**Addendum Three**

**PROJECT NAME & NO.:** File No.: 41/188/1/75

PROJECT NAME:  
**PROSPECT  
PUMP STATION**

**FORT PROSPECT  
CENTRAL AREA  
PUMP STATION**  
Fort Hill Road

**E5**

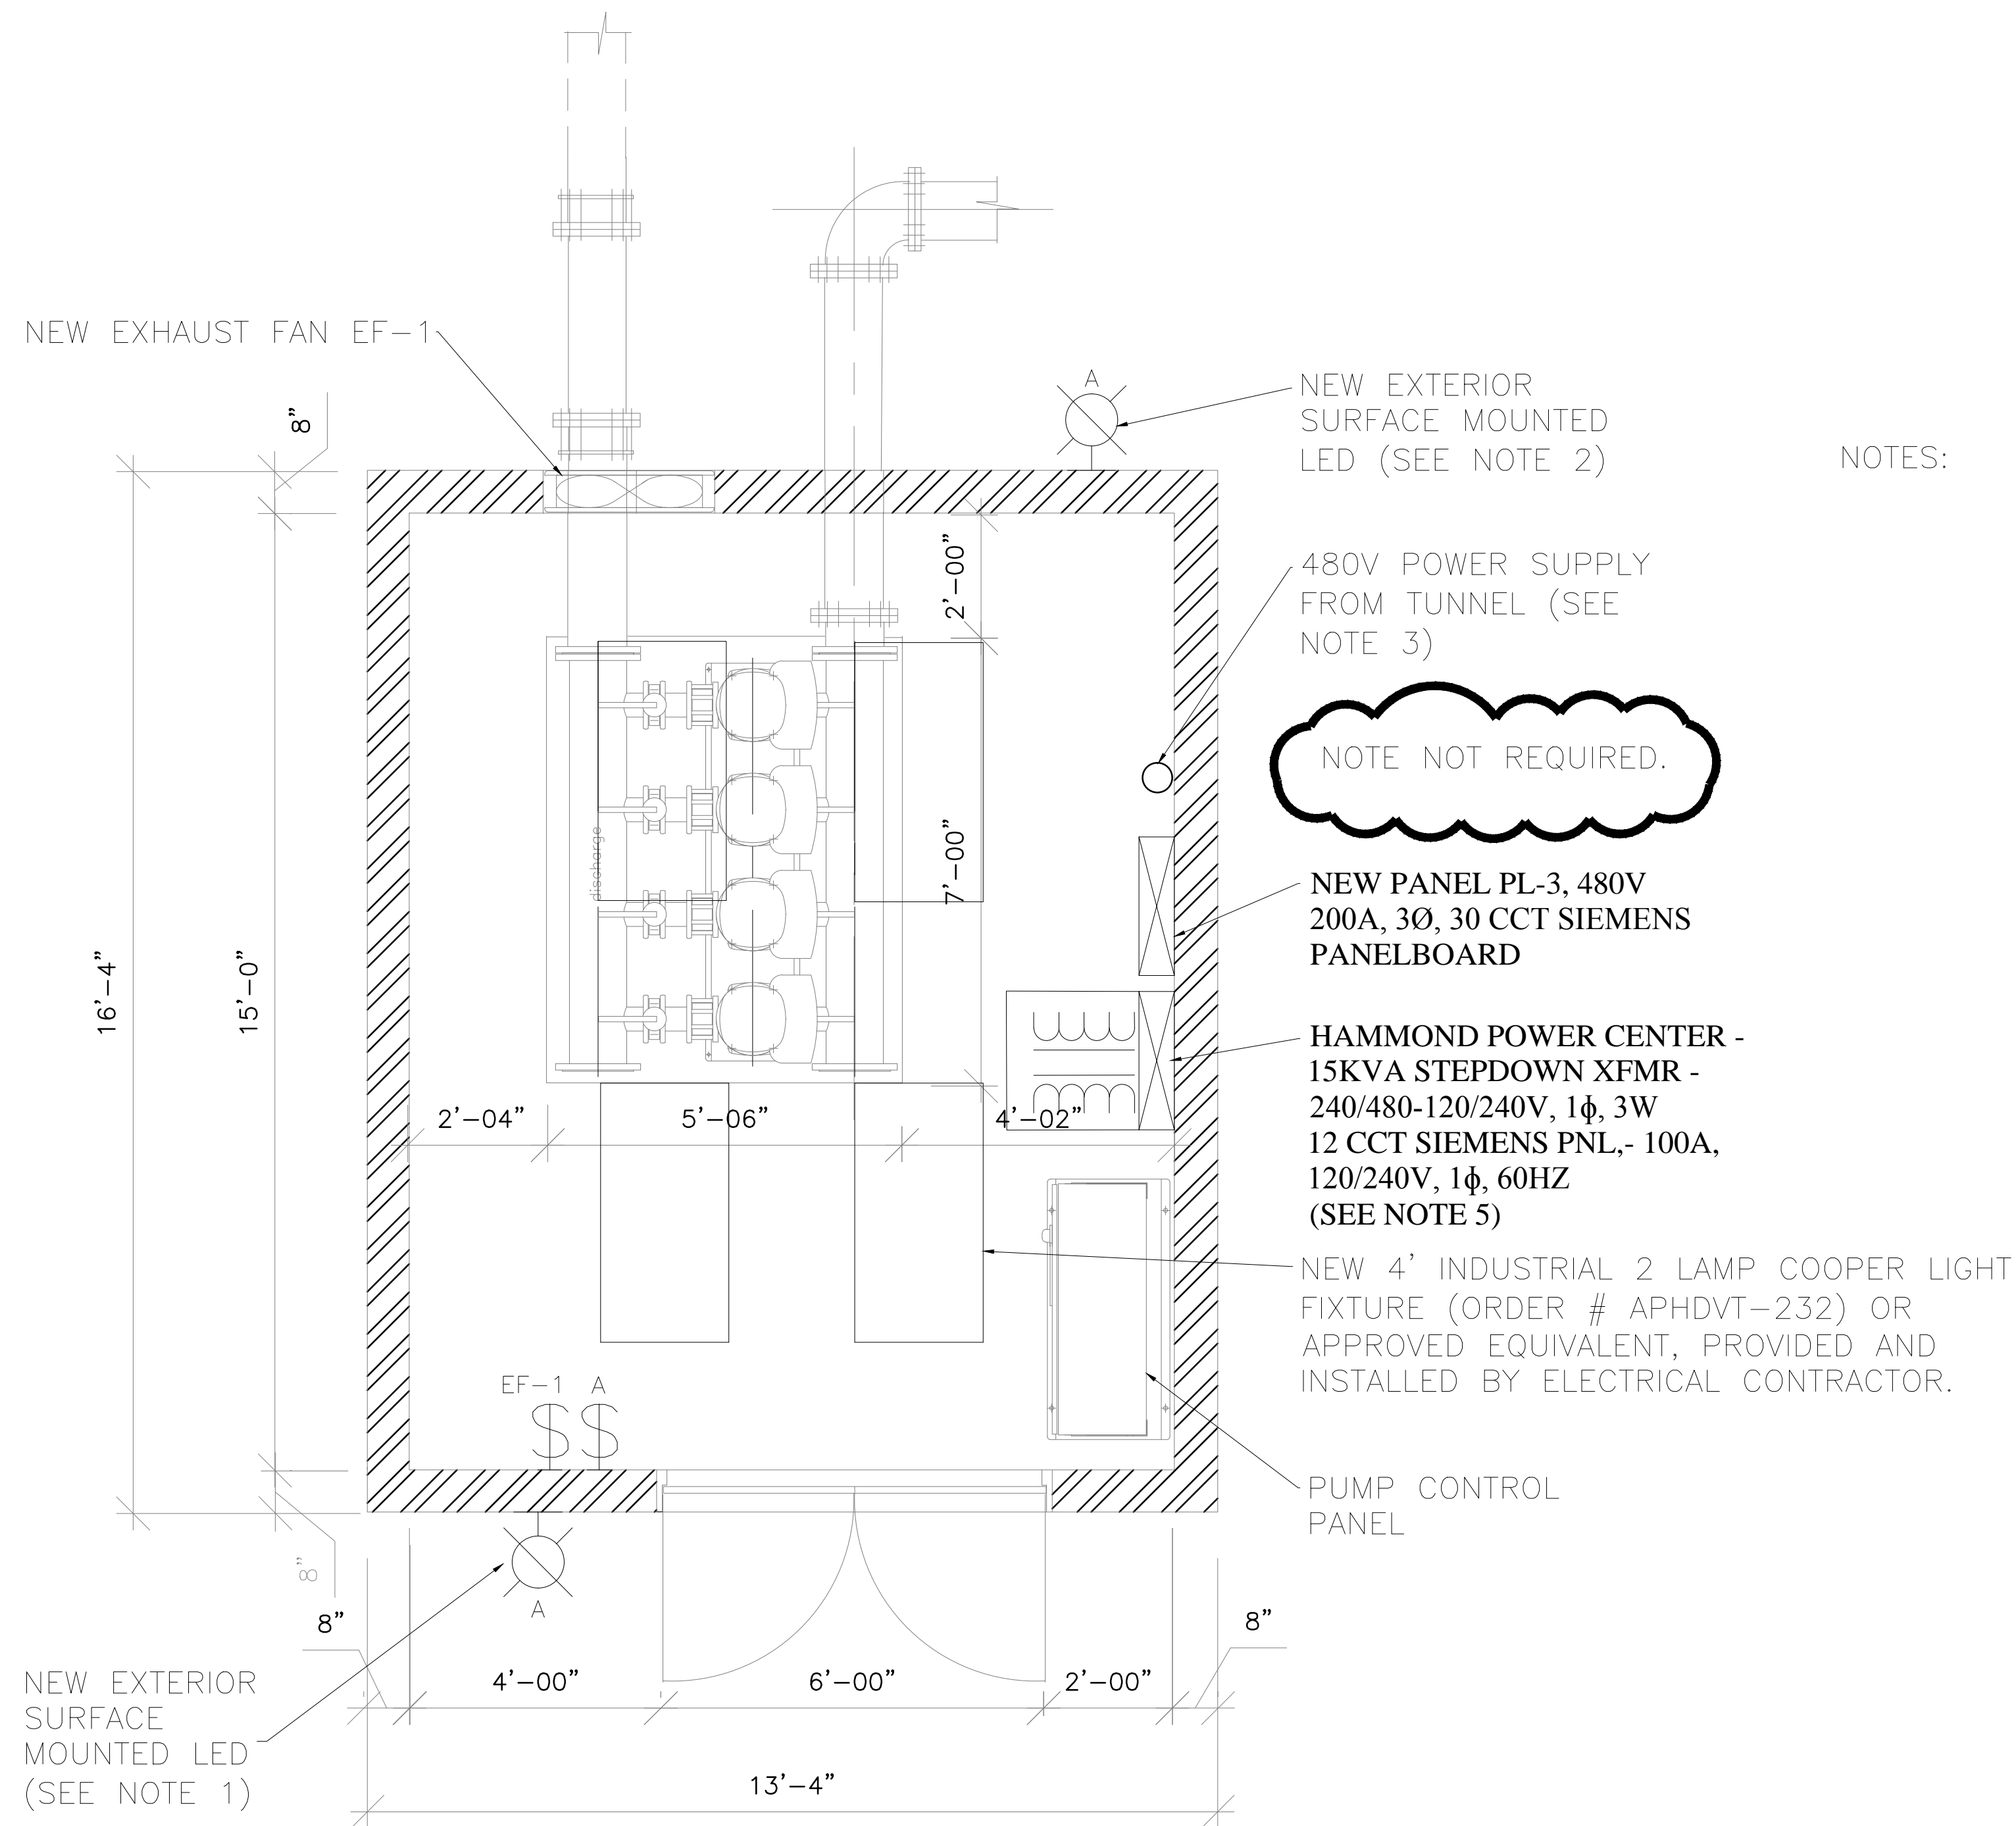
The connection to the generator shall be installed to act as temporary connection allowing connection and disconnection without tools. The connection point is to be a recessed junction box on the exterior of the existing control building to enable the generator to be positioned as shown.

The panel is to be surface mounted and complete with a mains breaker.

SHEET NUMBER: **E7**

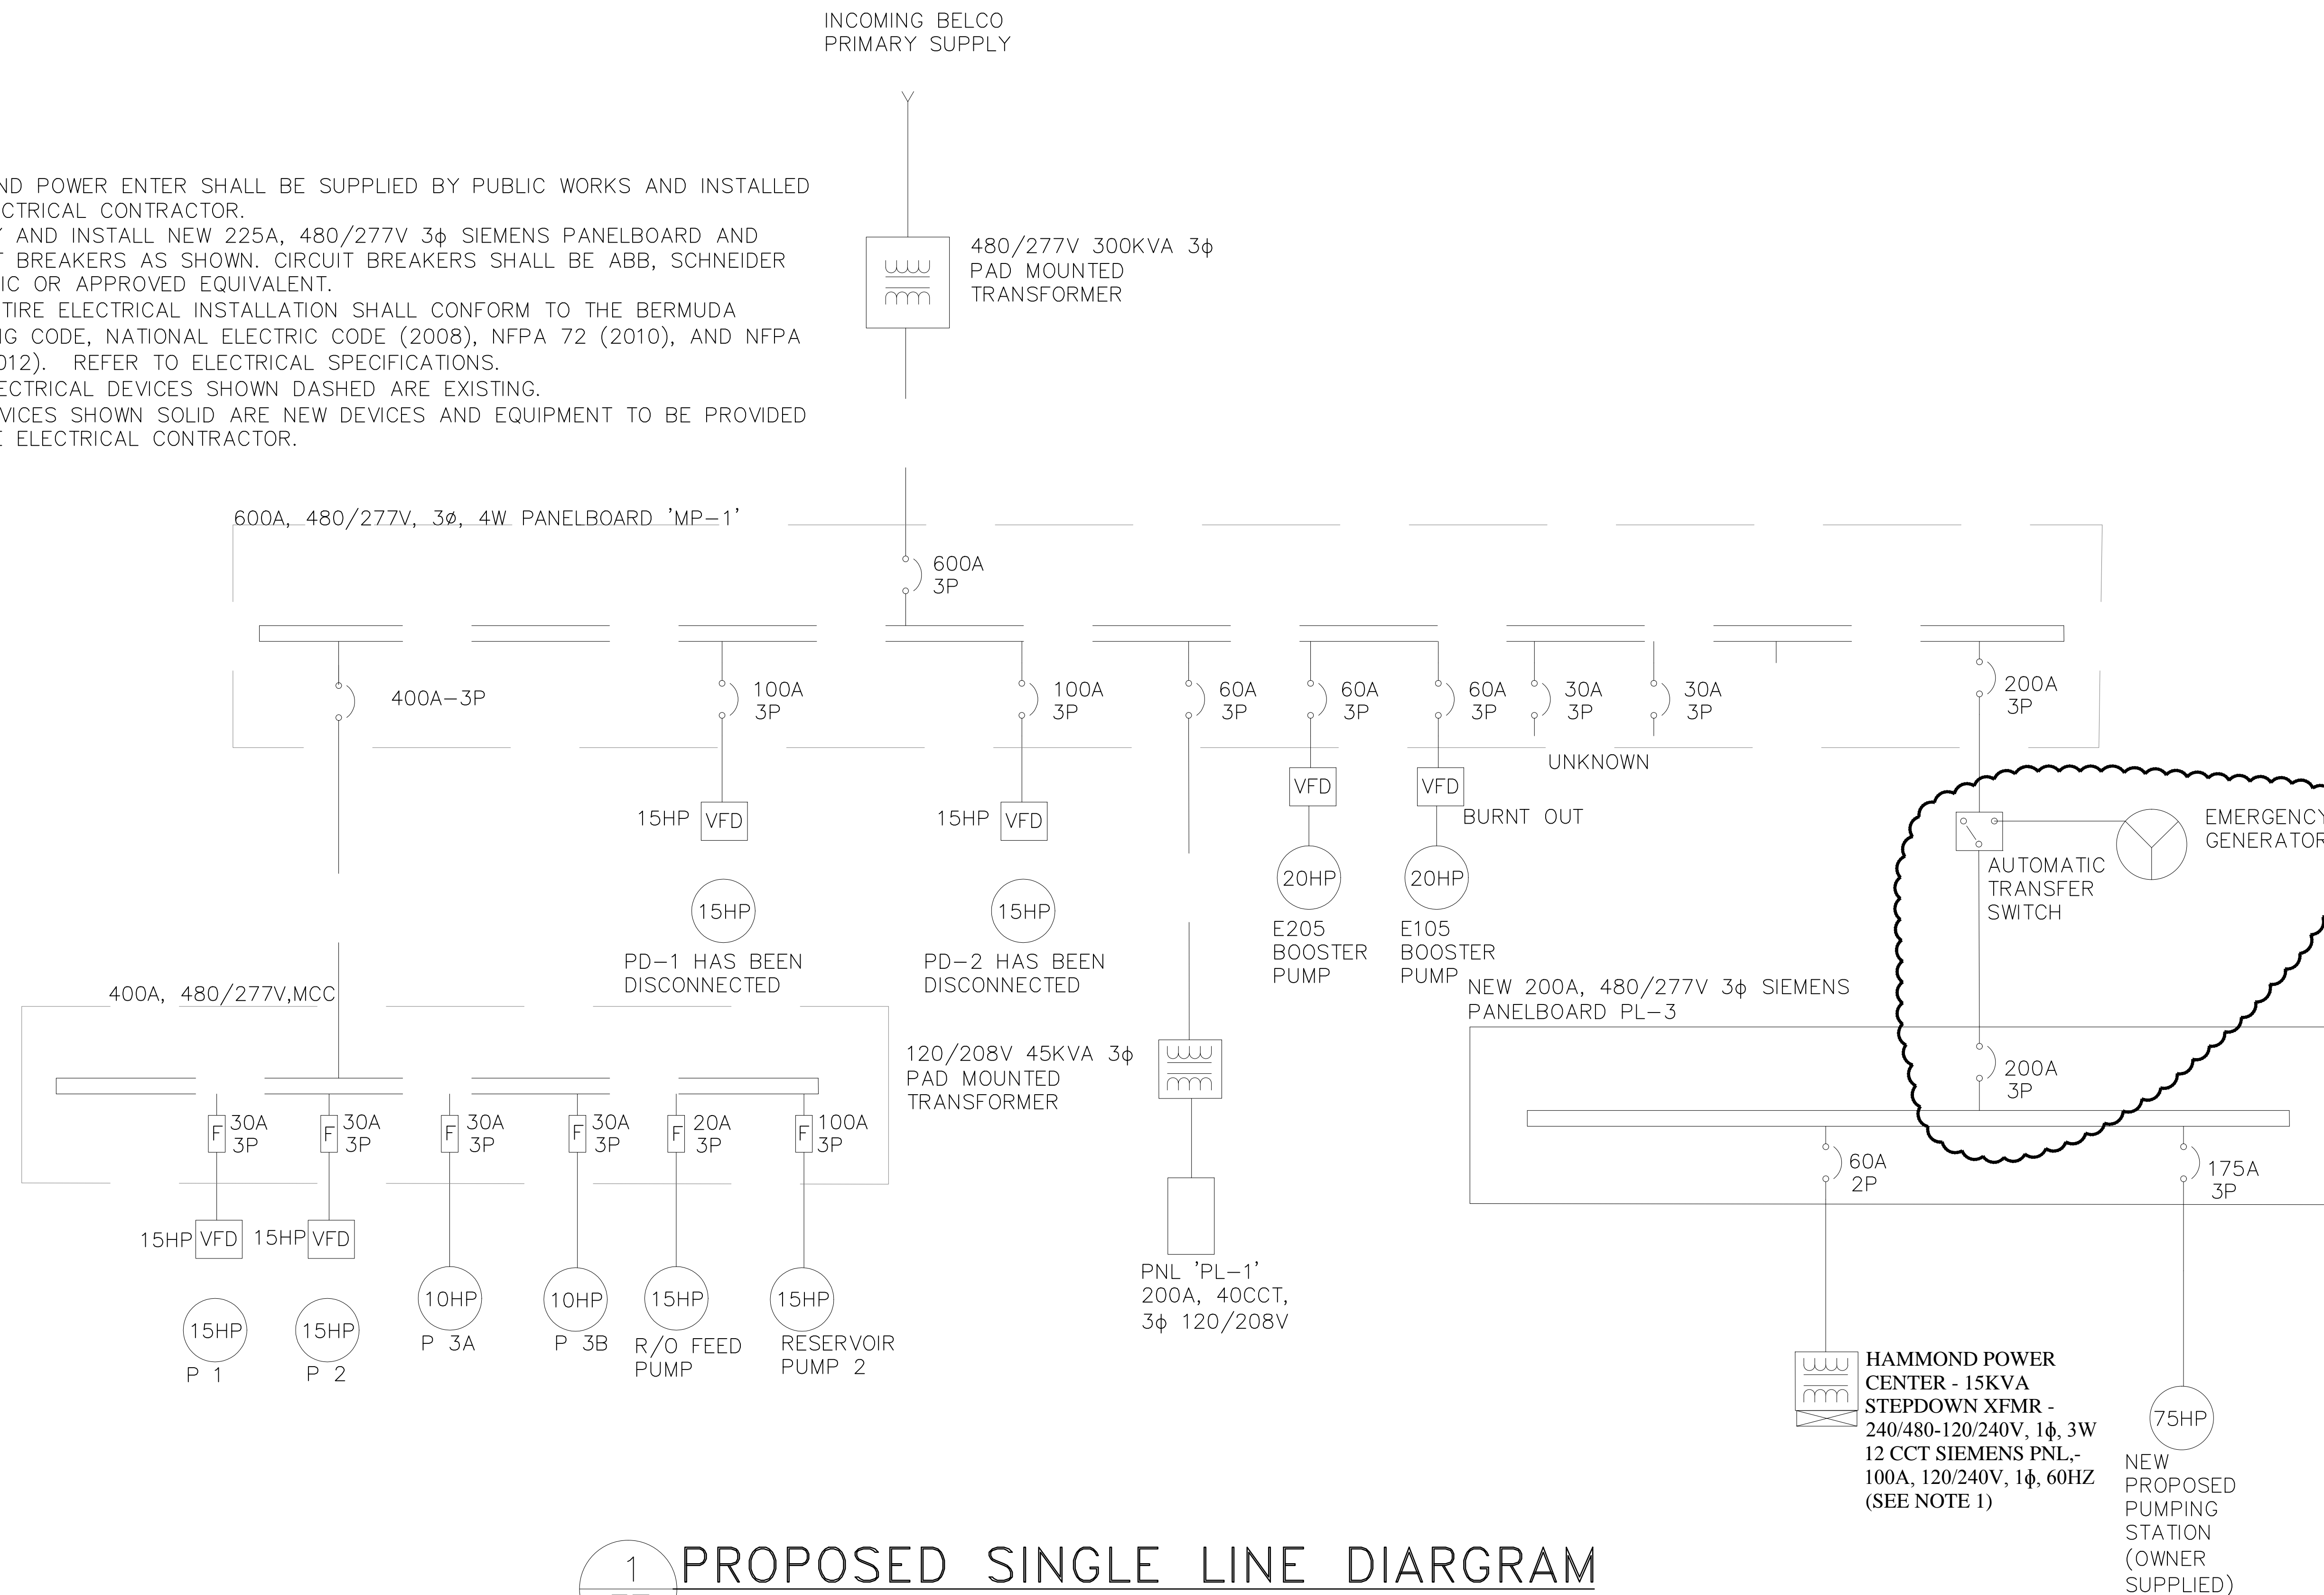
The ATS is to be a Kohler Model-KCS-ATMC-0299S 3pole, 4wire, solid neutral, 200A rated for 480v, 60Hz complete with NEMA type 3R enclosure

The connection is to be made with a single set of cables of 4x 1/0AWG + #6 GND
